RE: JMC Project 20029  
Edward Jones Office  
150 Bedford Road  
Town of North Castle, NY

**Response to Town Comments Submission**

**Town of North Castle Planning Department, July 4, 2020**

**Kellard Sessions Consulting, P.C. Memorandum, dated July 9, 2020**

3 TRASH ENCLOSURE DETAIL  
3/4" = 1'-0"

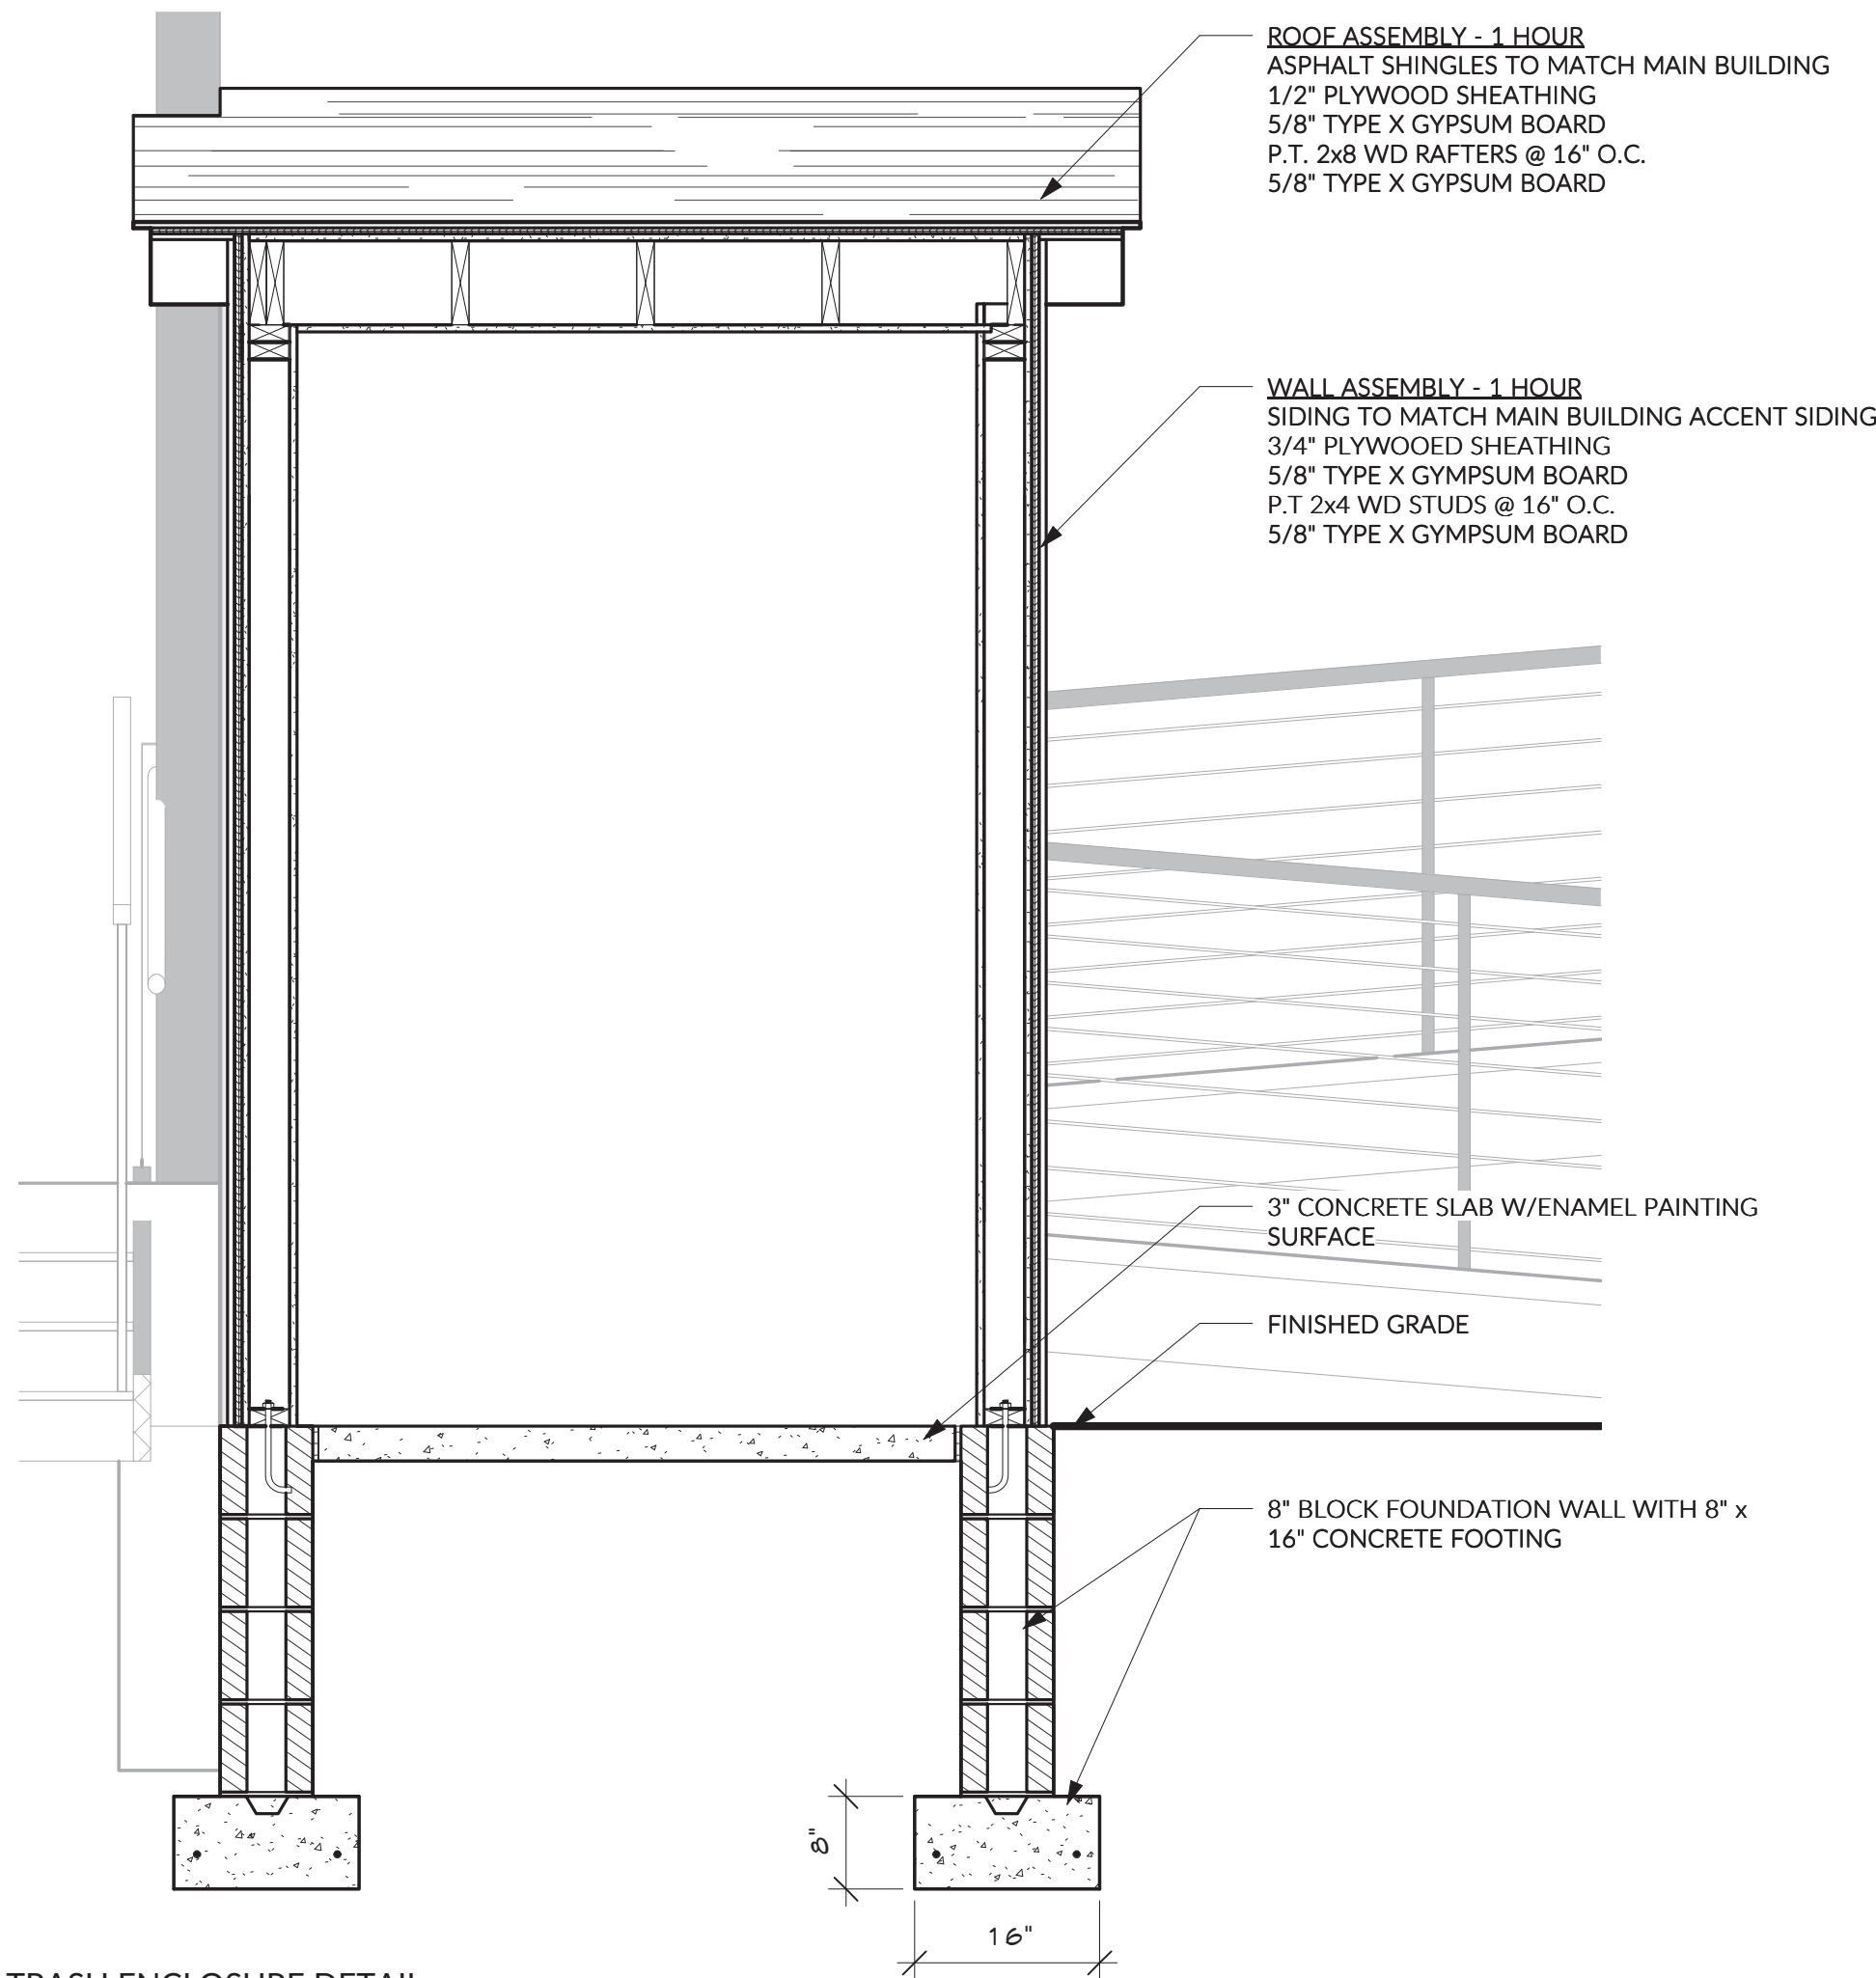
*The site plan shall depict a refuse collection detail for review.*

*A detail for the proposed refuse enclosure shall be provided.*

The refuse collection area has been relocated from below the open stair structure to an enclosure located adjacent to the accessible parking space in a code compliant structure which maintains required accessible aisle clearance compliance.

A detail for the proposed trash enclosure has been provided. Refer to Nexus Creative Design Drawing A-4 "Building Sections".
